## **SOUTH WEBER CITY PLANNING COMMISSION AMENDED AGENDA**

Our office has completed a review of the Final Plat and Improvement Plans for the Harvest Park Subdivision Phase 1, dated November 14, 2018. We recommend approval subject to the following items being addressed prior to approval from the City Council. Some items are mentioned for information purposes only.

# Harvest Park Subdivision Phase 1 Improvement Plans

Pebble Creek Drive  
11+50.00 - 16+00.00

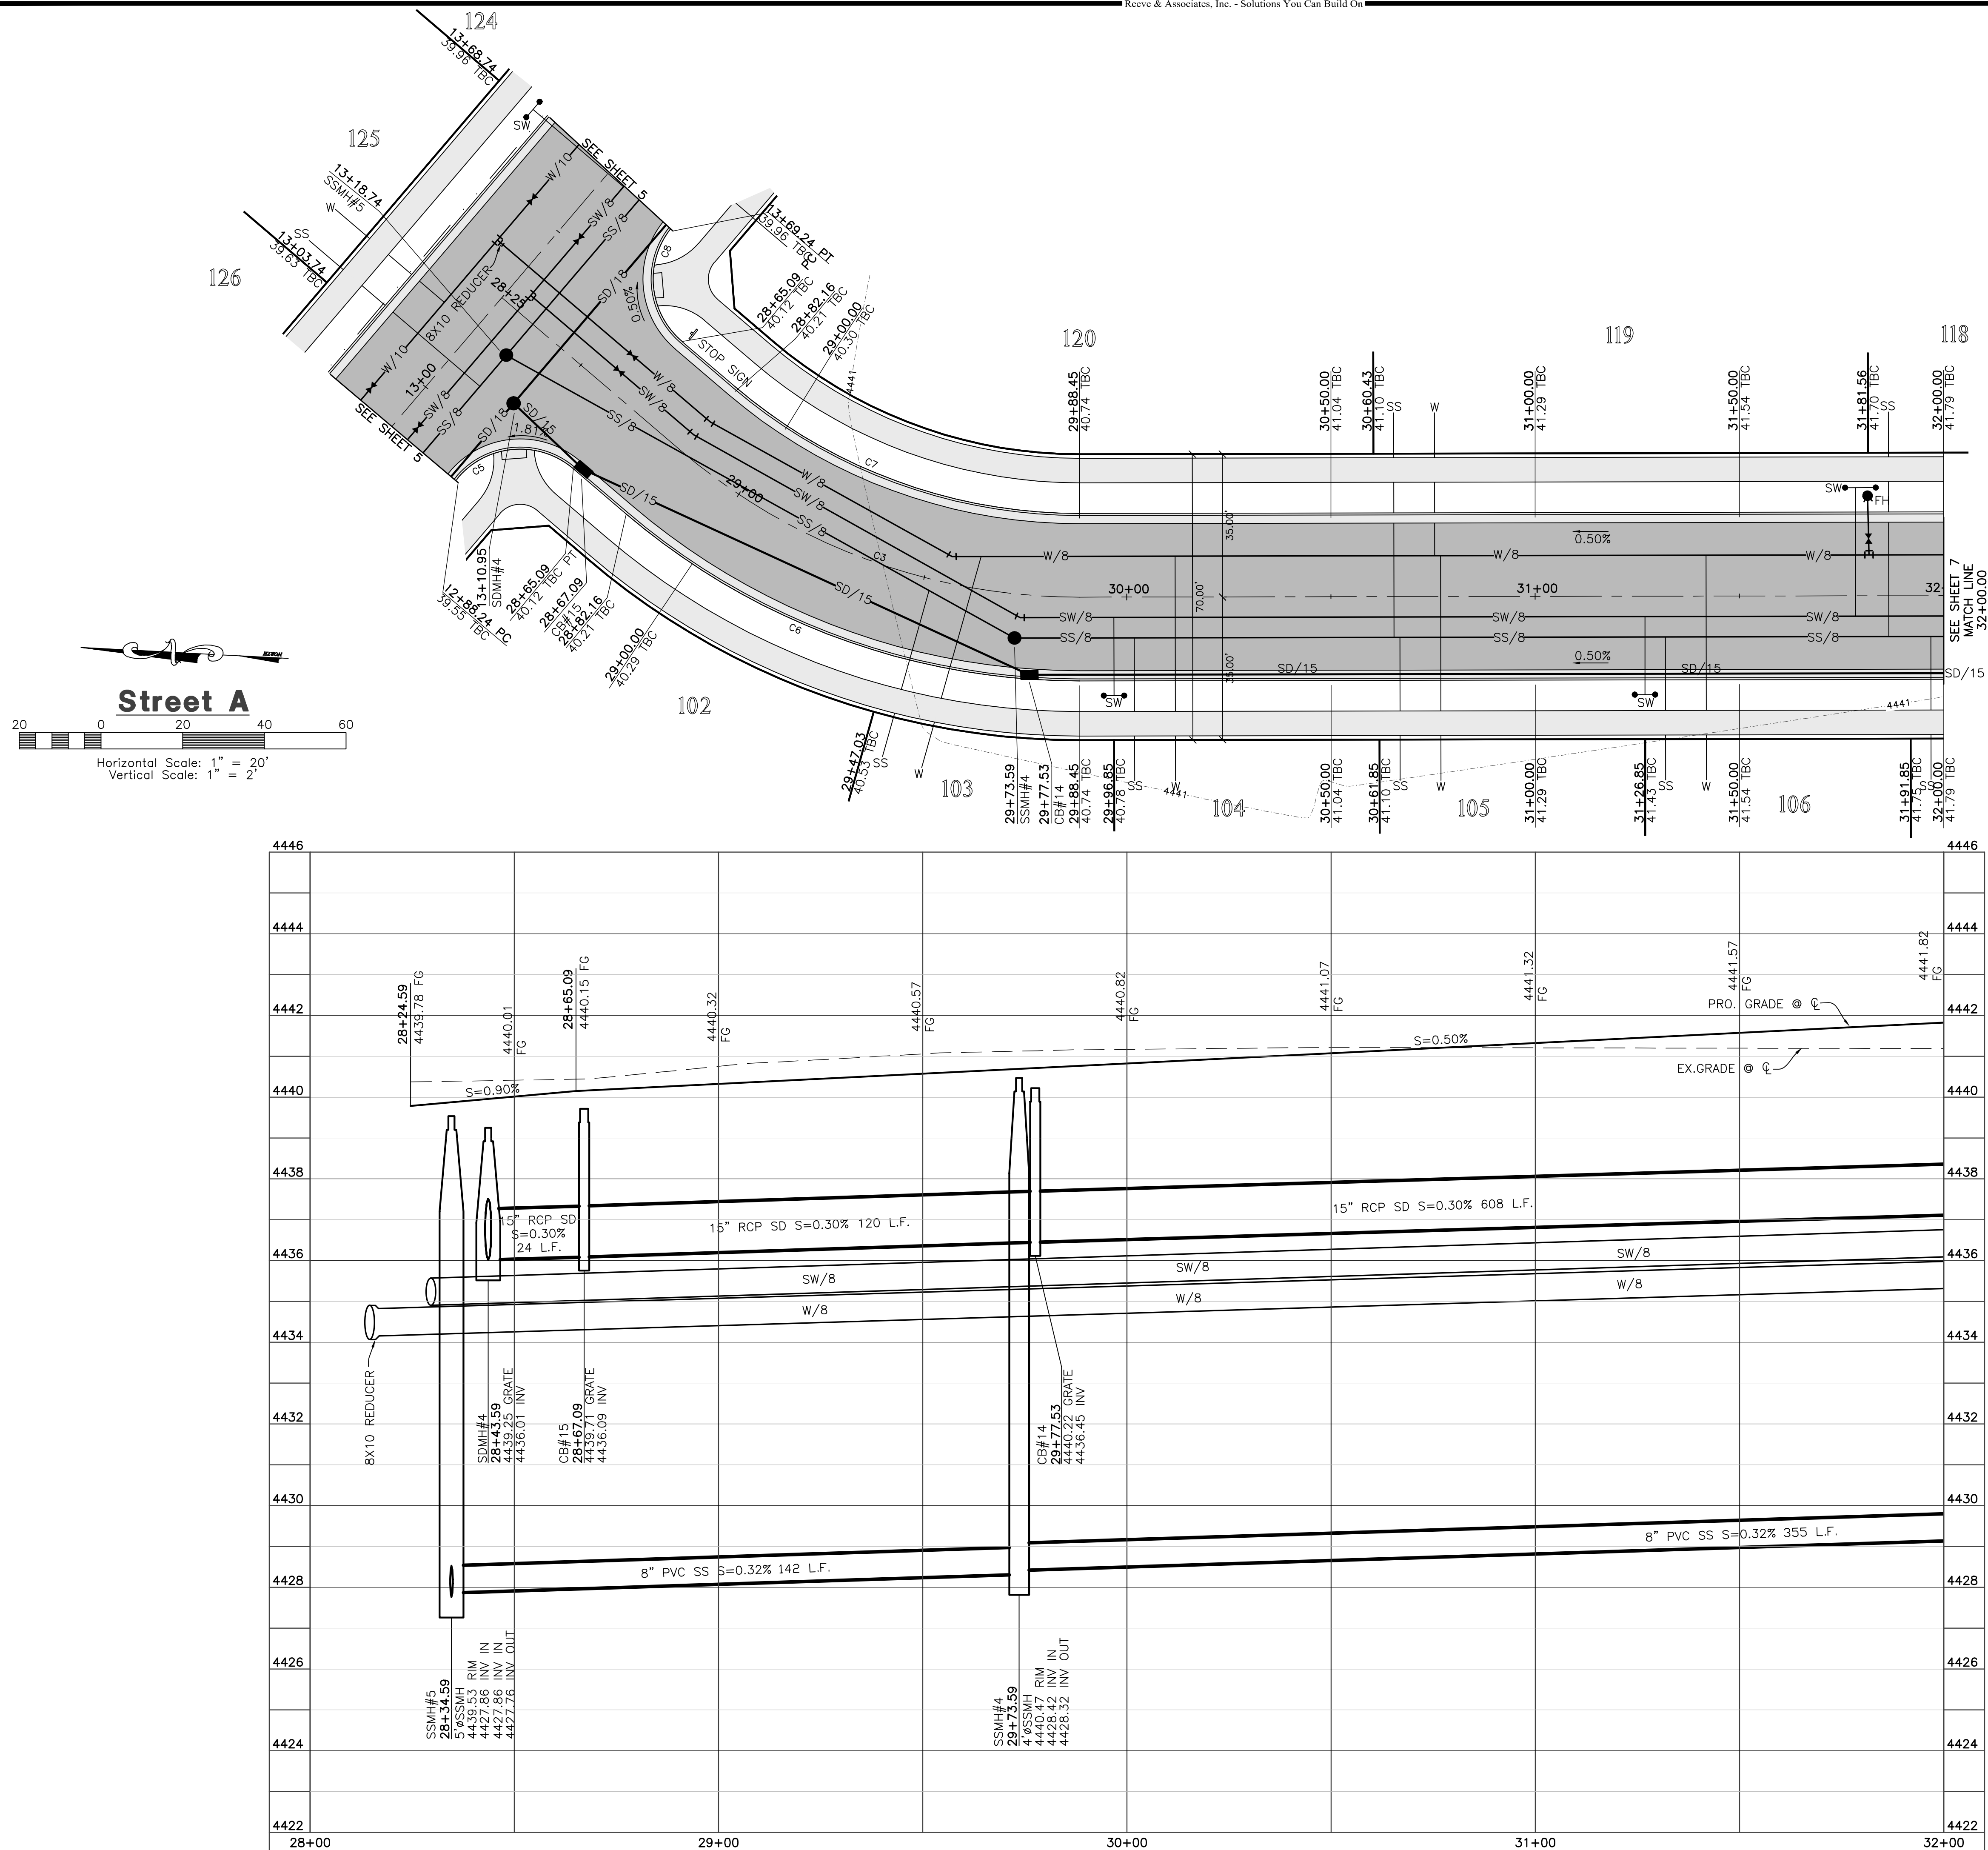
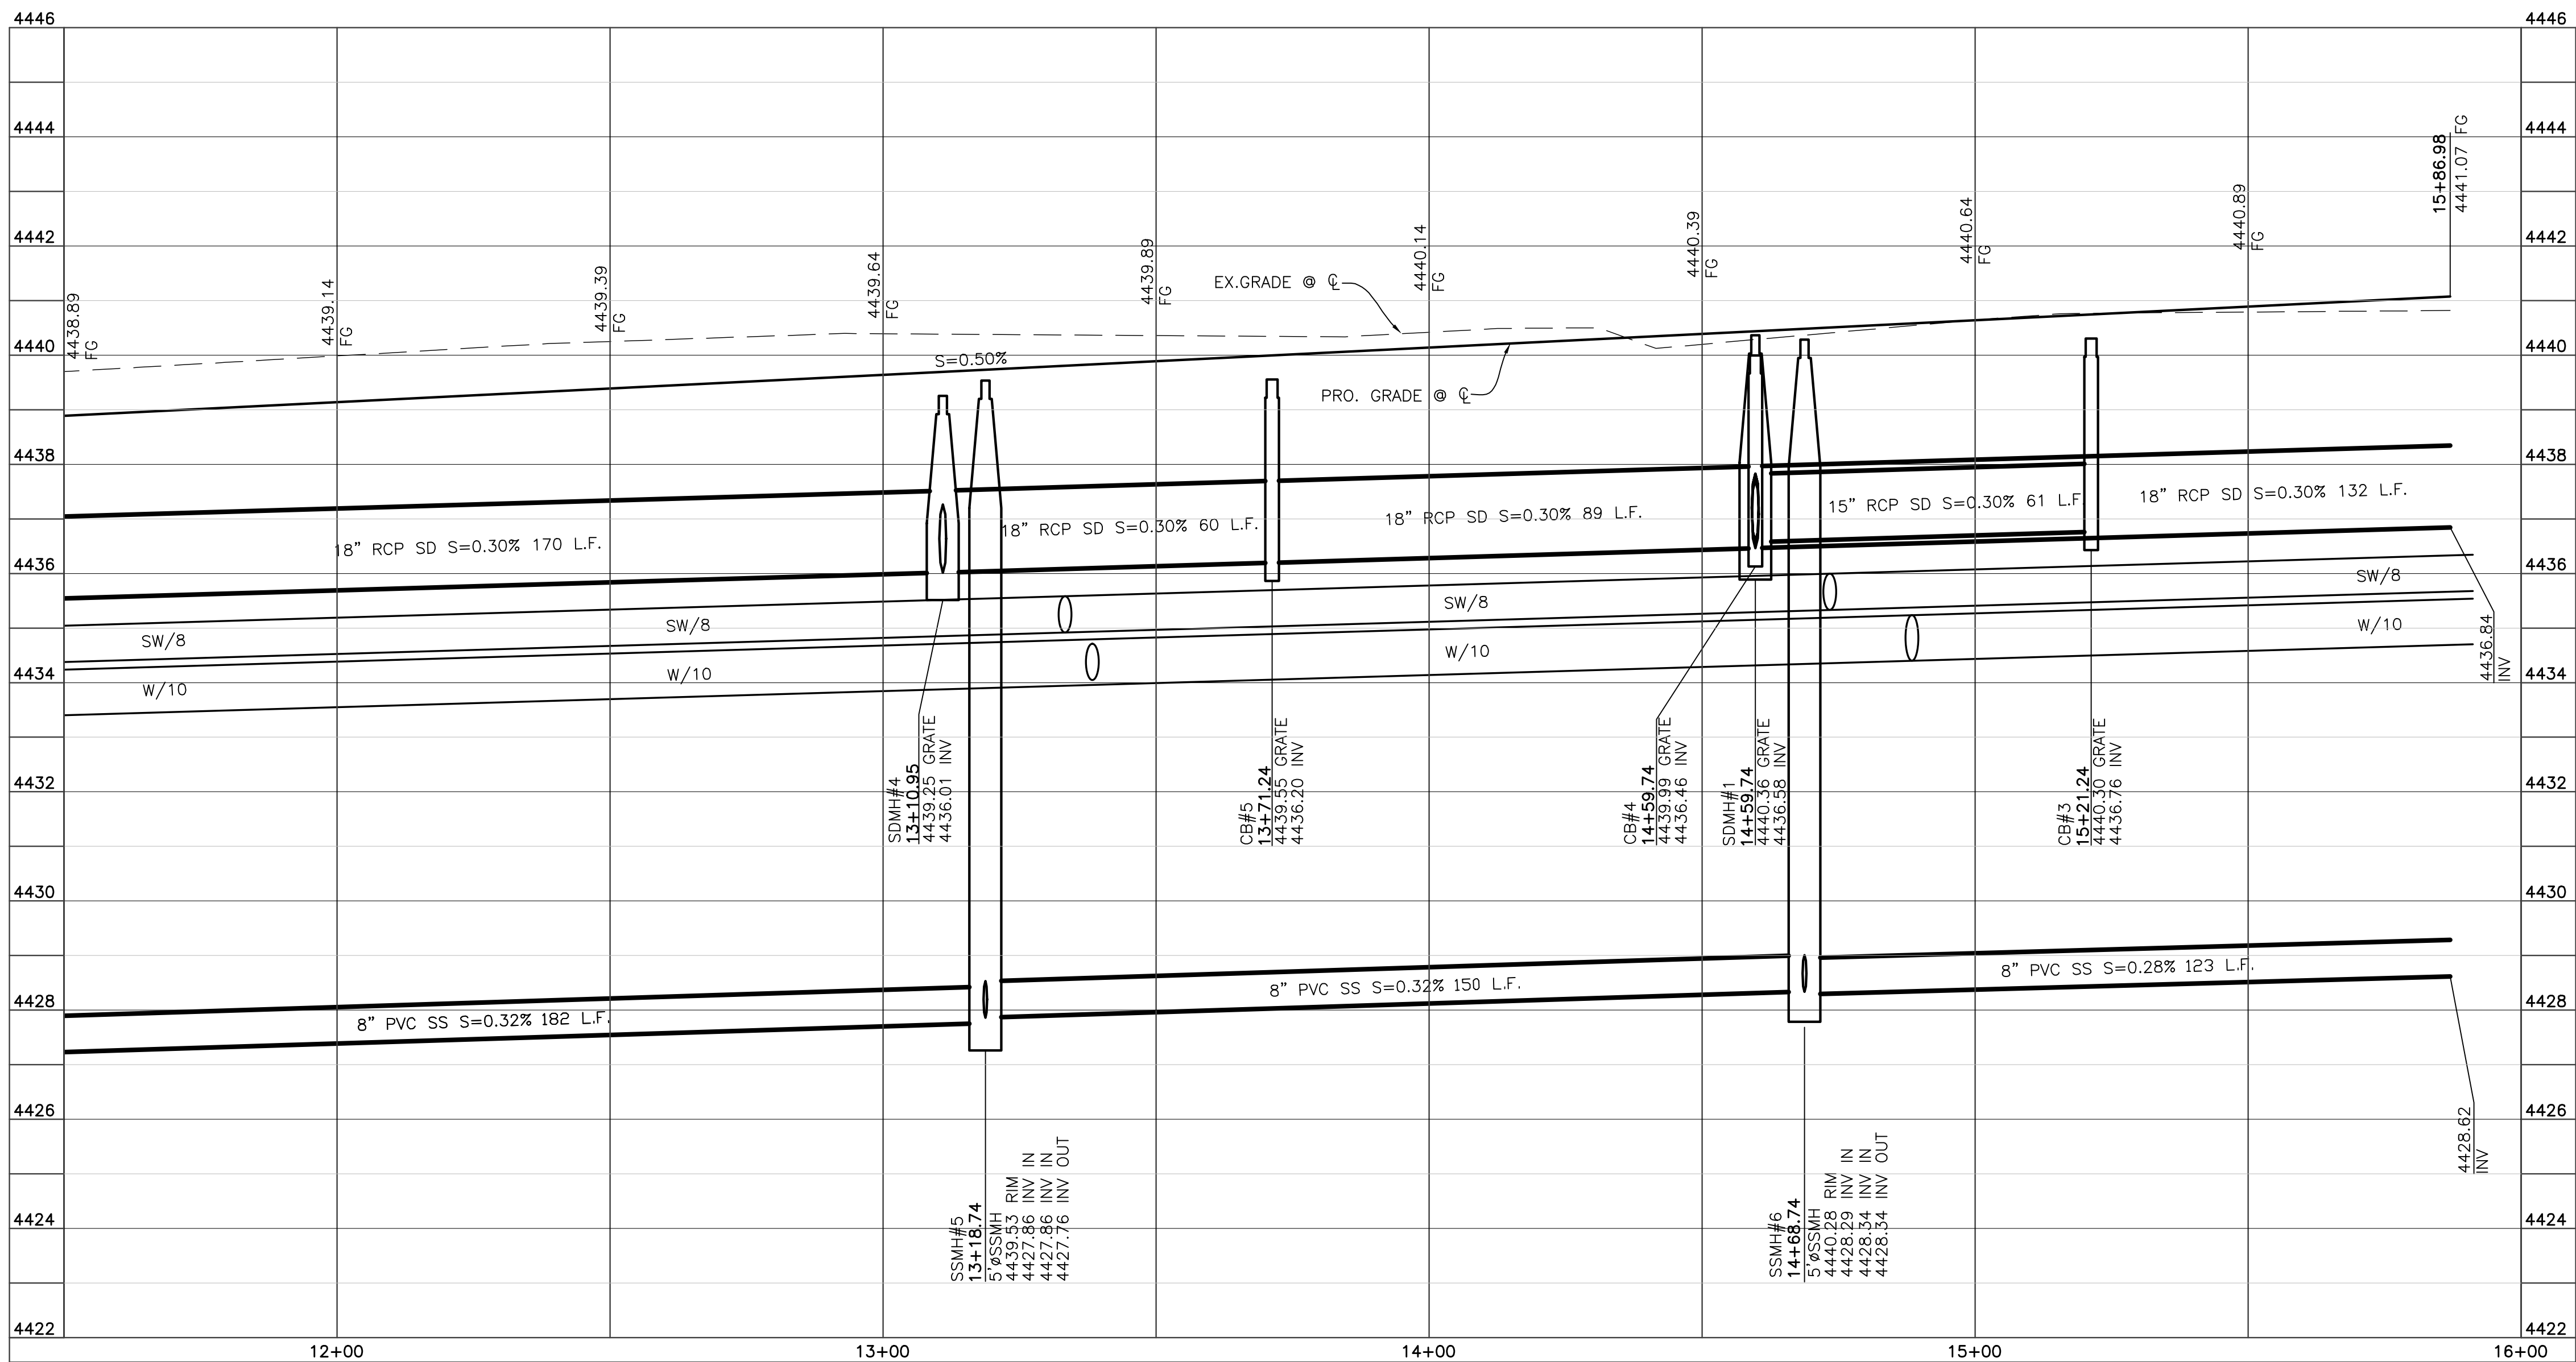
11. The plat needs to be given a unique name, perhaps Canyon Meadows Drive Road Dedication Plat.
12. The streets need to be labeled.
13. Centerline information and monuments need to be added.
14. The ROW radii at the east connection with Harvest Park appear to be reversed and potential don't match correctly.

**Harvest Park Subdivision Phase 1**  
SOUTH WEBER CITY, DAVIS COUNTY, UTAH  
**Utility Plan**

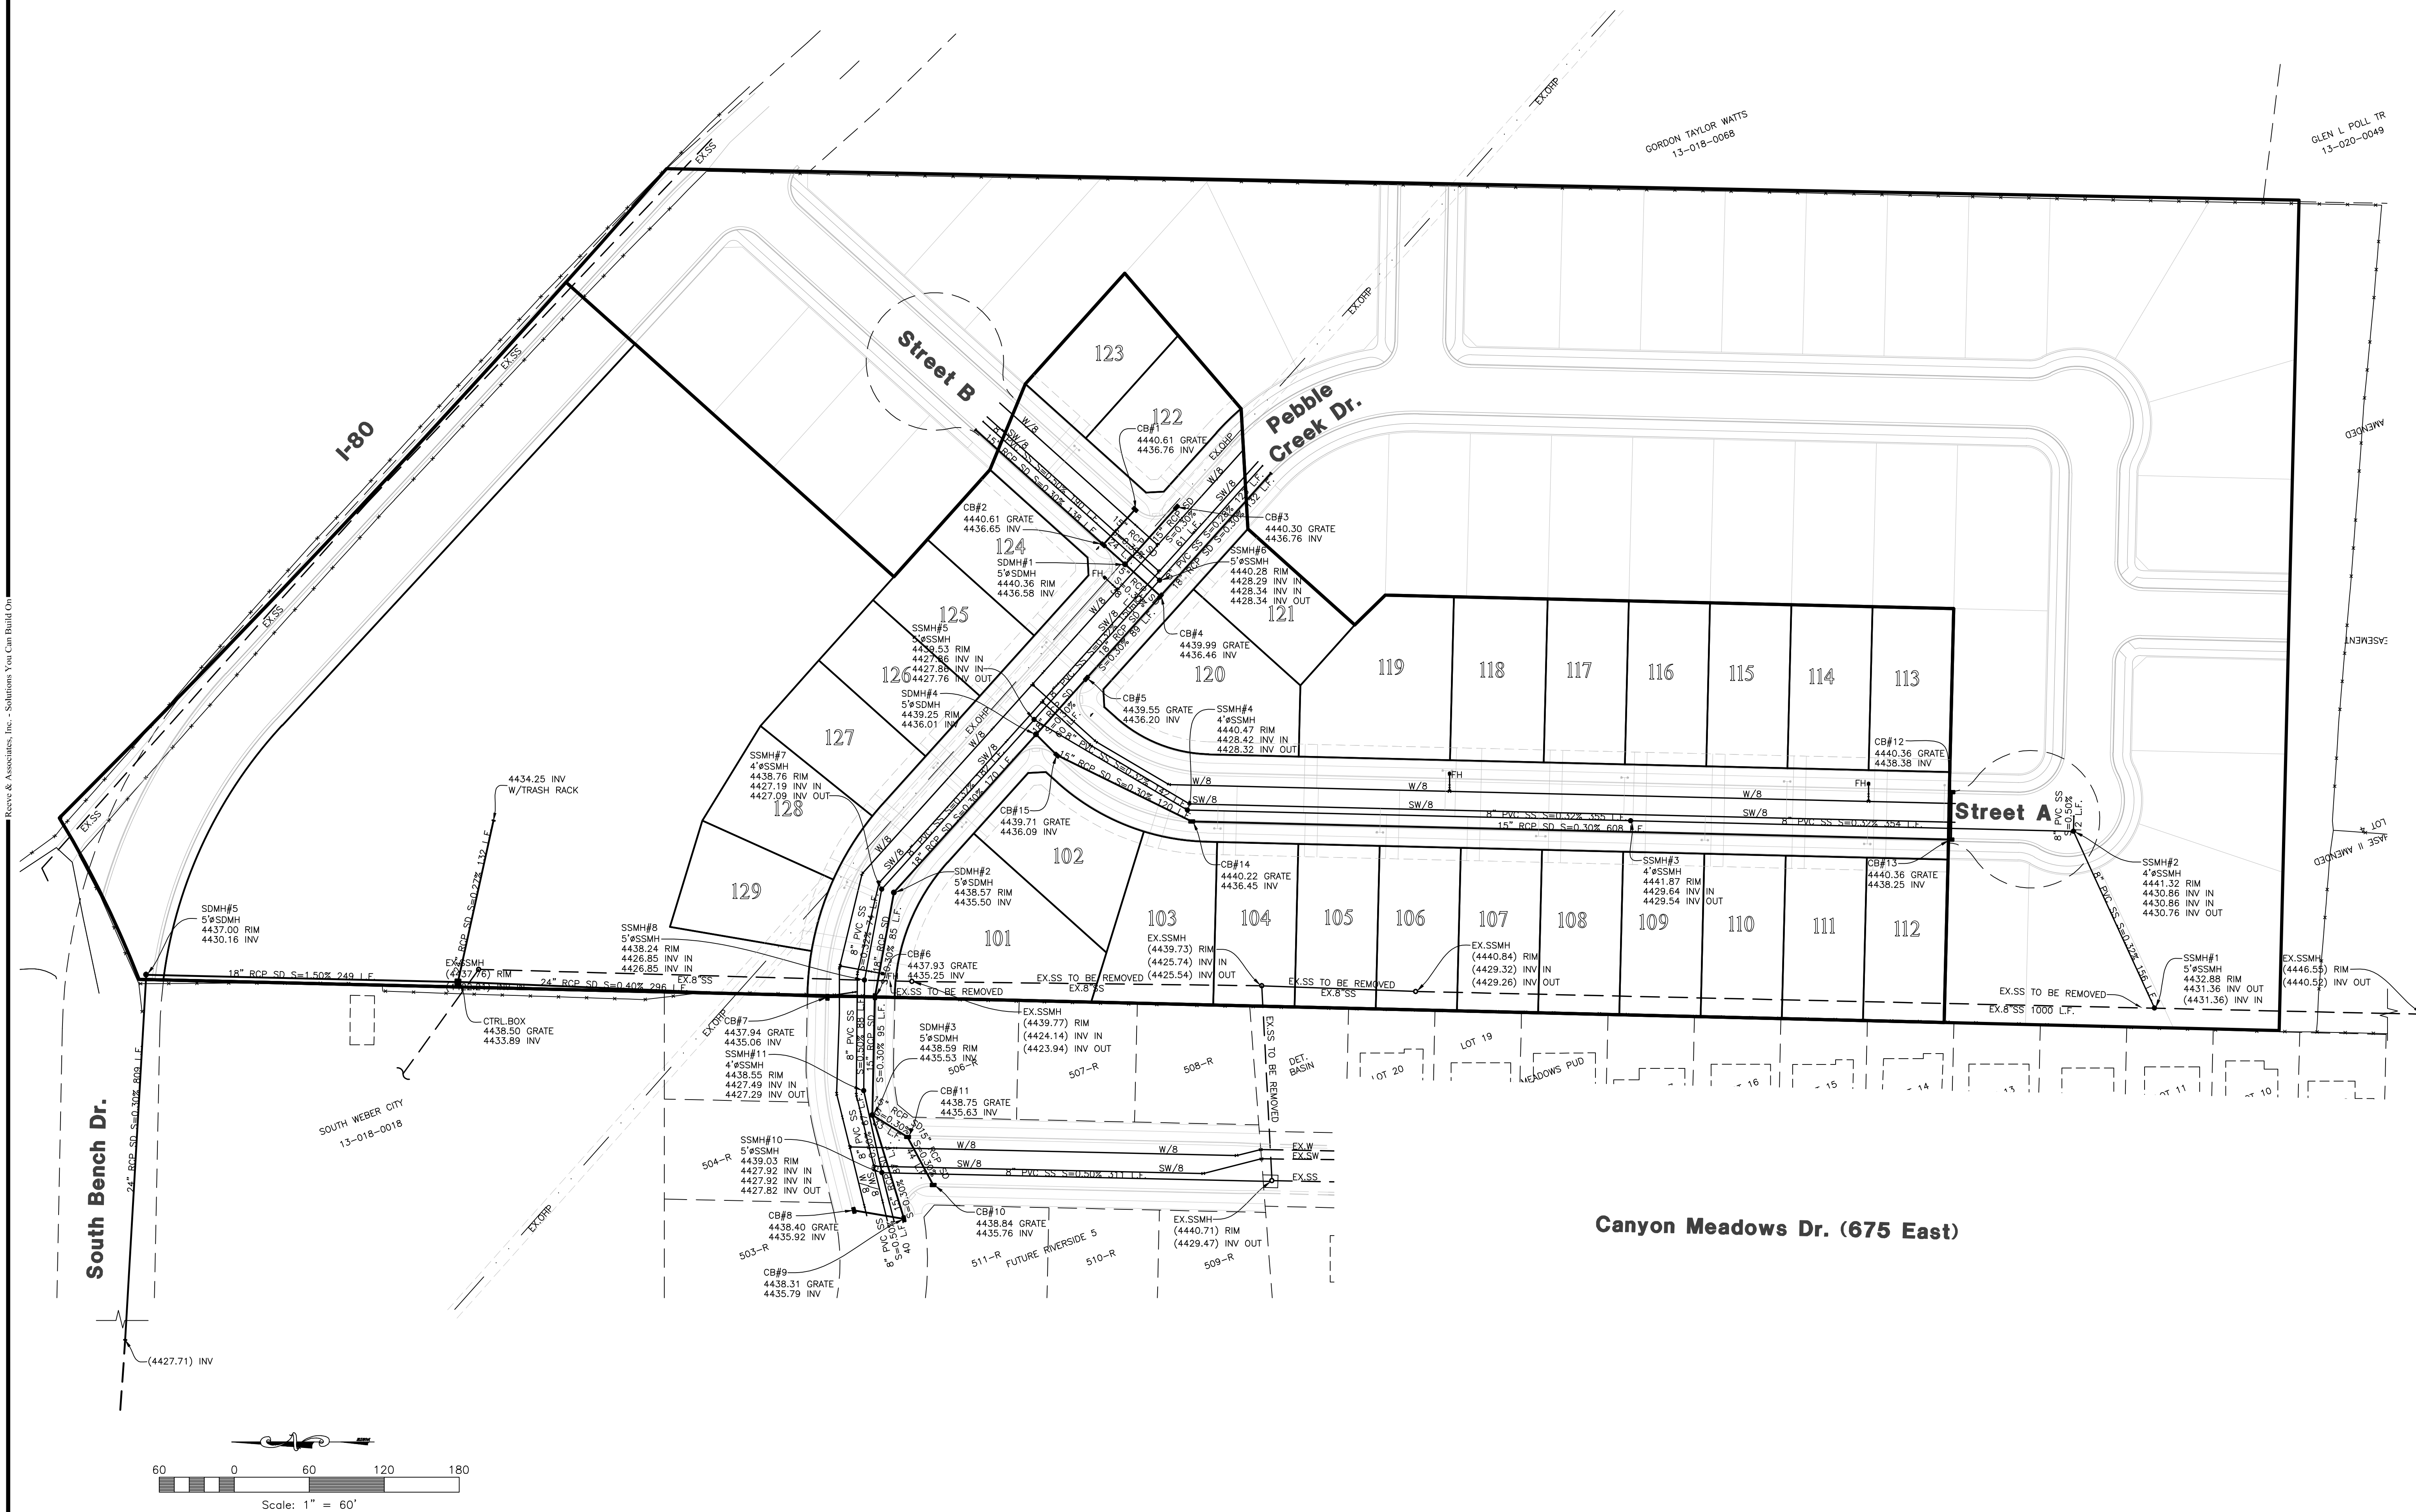
16. The Utility Plan and/or each Plan and Profile sheet should add notes indicating:
  - a. The approximate depth of groundwater in order to notify the contractor. The sewer is very deep and groundwater will be an issue in getting it installed.

- b. That imported trench backfill will be required wherever unsuitable conditions are present within the street ROW.
17. Existing asphalt and curb and gutter need to be removed at the connection of Canyon Meadows Drive in order to provide a smooth transition between the grades of the two roads.
